RTPG – the Rifkin Transportation Planning Group

June 12, 2018

COMMENTS ON TRAFFIC IMPACTS FOR THE PROPOSED MOUNT SAINT MARY'S UNIVERSITY WELLNESS PAVILLION PROJECT AT 12001 WEST CHALON ROAD ENV-016-2319-EIR

INITIAL STUDY
TRAFFIC ANALYSIS

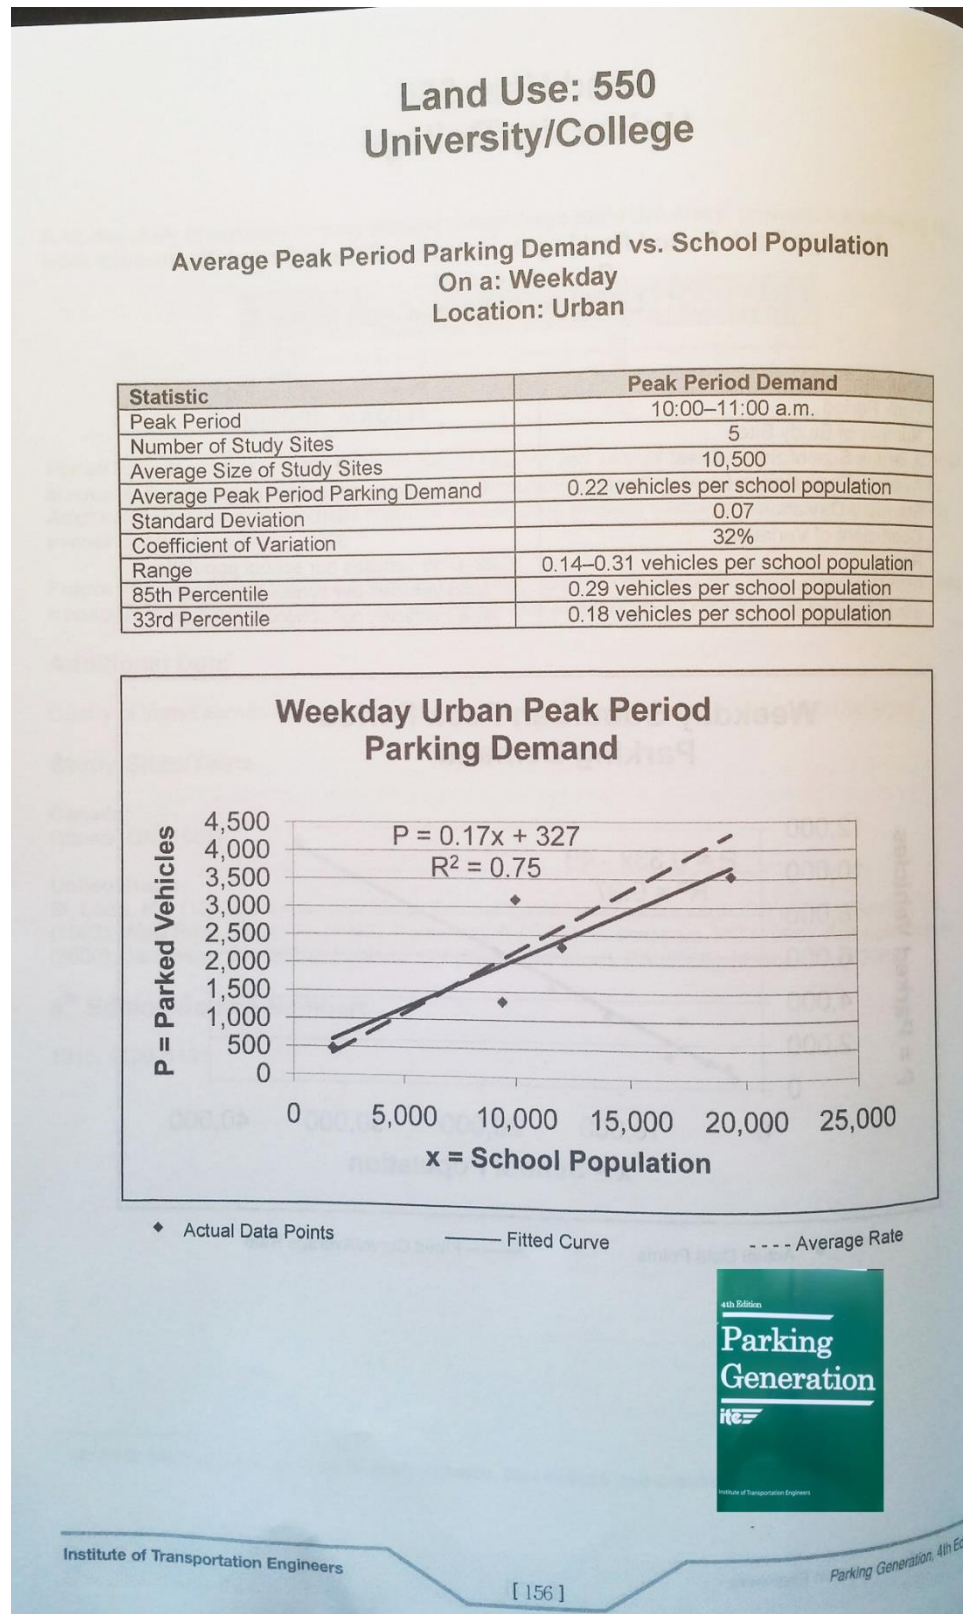
As mentioned above, I was Transportation Planning Bureau Chief at LADOT in 1984, when the Initial Study Traffic Analysis document (**EXHIBIT 2**) was signed by LADOT Traffic Engineer Charles King, and, at that time, I was his immediate supervisor. With direct knowledge of procedures in place at LADOT, I am especially qualified to interpret the findings of the Initial Traffic Study Analysis and the associated approval for the parking structure.

Contrary to what MSMU asserts, LADOT issued the "NOT SIGNIFICANT" traffic impact determination for the July 1984 CUP with the condition that enrollment would not increase. If the permit was to provide for increased student enrollment, LADOT would have required further assessment of the added vehicle trips to determine the need for a traffic study and ultimate assessment of traffic impacts.

EXHIBIT 5 – ACCESS ROUTE TO MSMU CAMPUS

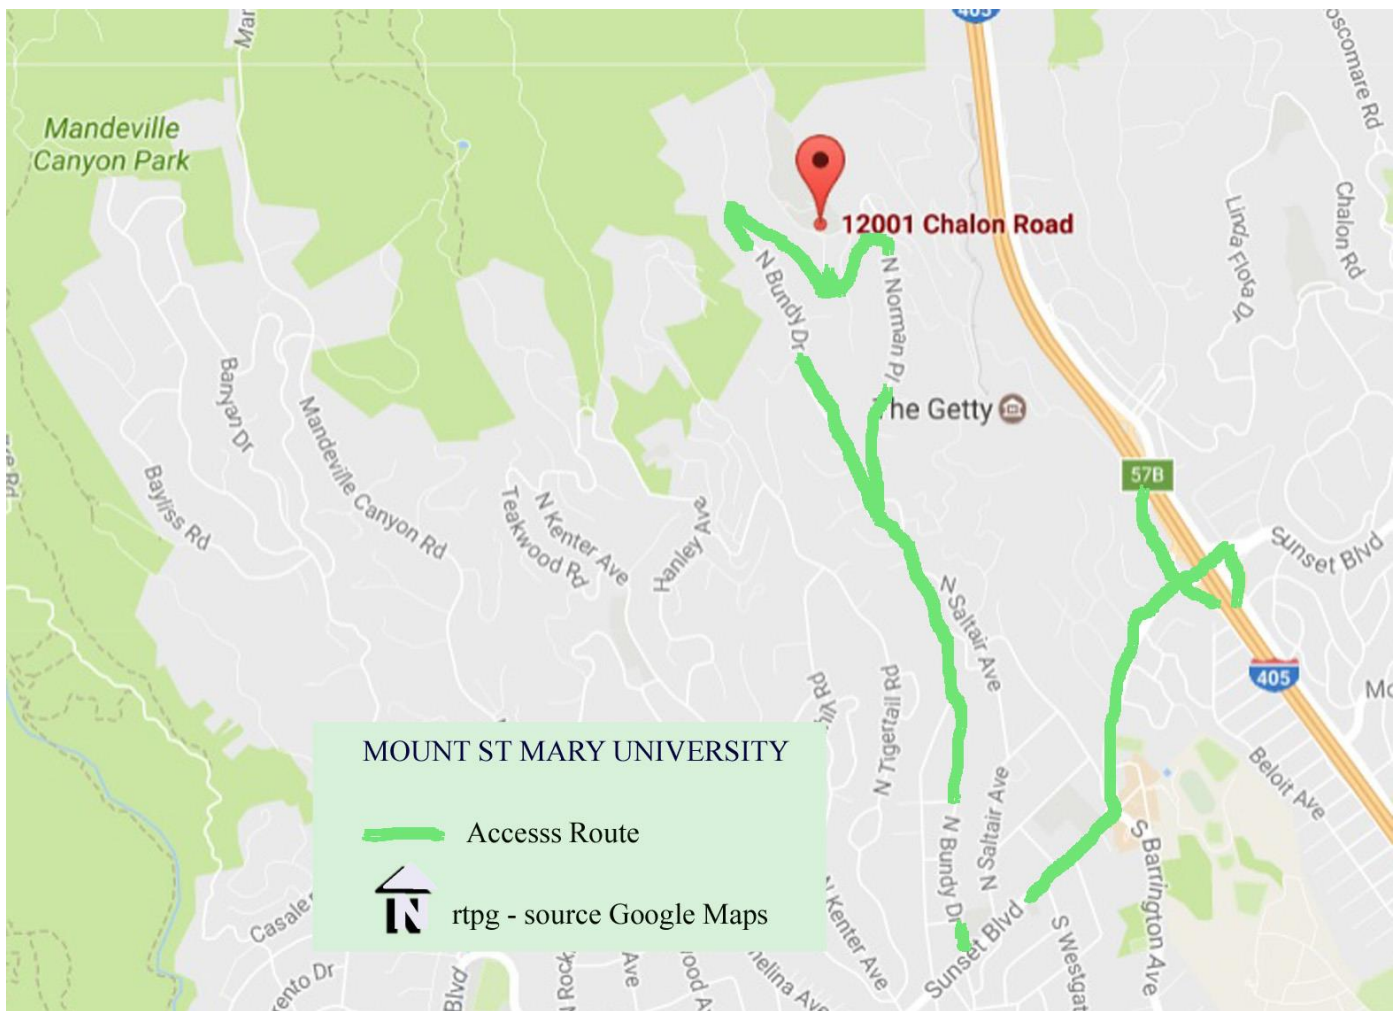
EXHIBIT 5 shows the route to the campus from the Sunset Boulevard Corridor, namely Bundy Drive, Norman Place and Chalon Road. According to the Circulation maps from the latest adopted Brentwood-Pacific Palisades Community Plan and the Circulation Element of the Citywide Plan, all roads to the MSMU campus are designated as “local” roads (see **EXHIBIT 6**). This appears to be in conflict with more recently adopted designations from the Baseline Hillside Ordinances (Ordinance No. 181,624 and Ordinance # 168,159), wherein these roads are designated as “Hillside Limited Streets.” In both of these criteria, the intention of these roads is that they **“are intended to accommodate lower volumes of vehicle traffic.”**

During my field investigation, I measured these roads and found the roadway width to narrow from 30 feet wide (nearest to Sunset Boulevard) down to less than 19 feet wide on Norman Place in its approach to Chalon Road which is the entrance to the campus. As evidenced by pictures of the route which are attached in **EXHIBIT 9**, these roads are very narrow, windy, lacking sidewalks and with limited sight-line. **Those sections of roadway below 20-feet are substandard by any of the City applicable standards and unsafe for two-way traffic.**
